Service Info

Tensioning arm 534 0325 10

Improved markings

Manufacturers:	Dodge, Mitsubishi
Model:	
Dodge:	Caliber
Mitsubishi:	ASX
	Lancer
Engines:	
Dodge:	1.8, 2.0, 2.4, 2.4 Turbo
Mitsubishi:	1.8
Part no.:	534 0325 10
OE number:	
Dodge:	04891976AC (replaced)
	04891595AD (new)
Mitsubishi:	1345A059 (replaced)
	1345A079 (new)

Image 4: Left, old M8x40 mm screws.
Right, new M8x30 mm screws.

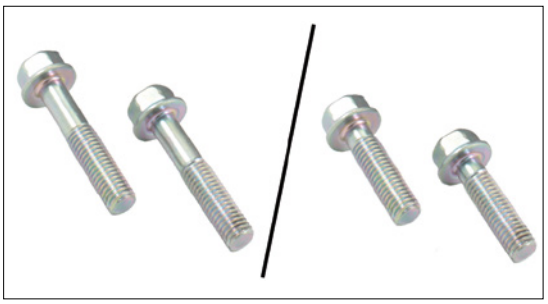
As a result of the modified attachment point dimensions, the length of the fixing screws has also changed. The M8x40 mm screws from the old version can no longer be used with the modified tensioning arm. They must be replaced with the M8x30 mm screws provided (image 4).

It is essential that the screws provided are used when installing the modified tensioning arm.
